ADDENDUM NO. [3] Date: March 12, 2019

RE: LACRESCENT-HOKAH PUBLIC SCHOOLS

HIGH SCHOOL PARTIAL REROOF

HSR 18068

ROOF PLAN - NORTHWEST

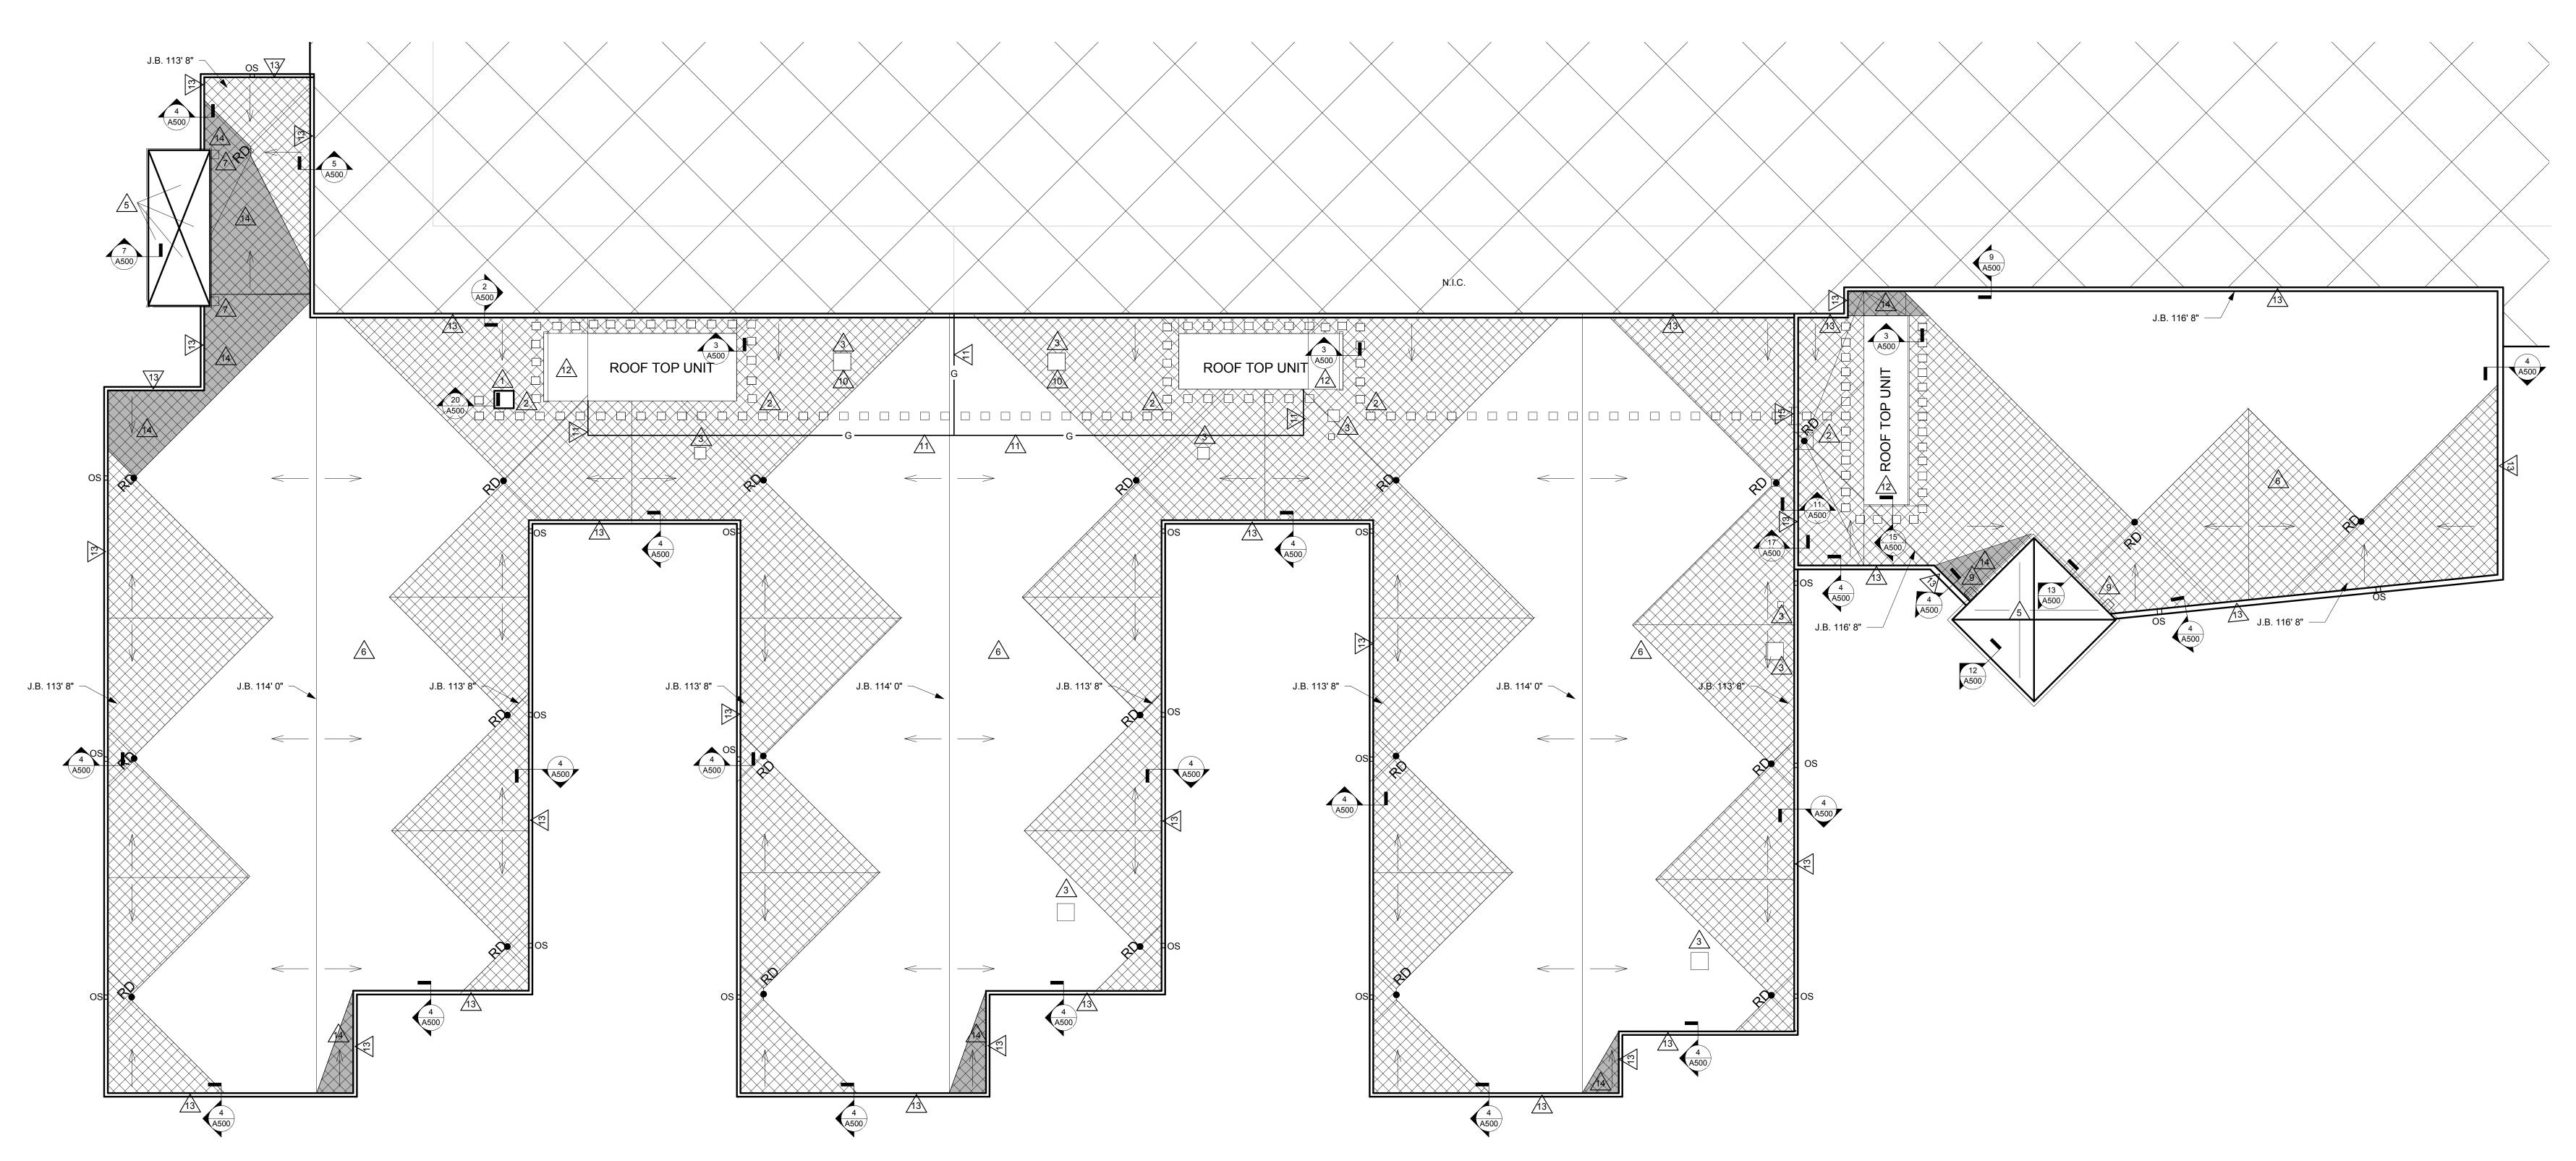
- 1. Sheet A120R OVERALL ROOF PLANS 30 x 42 attached hereto
 - a. Dimensions added to plan for both segments.
- 2. Sheet 121R ROOF PLAN (SECTION A) 30 x 42 attached hereto
 - a. Plans are not to scale. Dimensions included on A120R.
- 3. Sheet 121R ROOF PLAN (SECTION B) 30 x 42 attached hereto
 - a. Plans are not to scale. Dimensions included on A120R
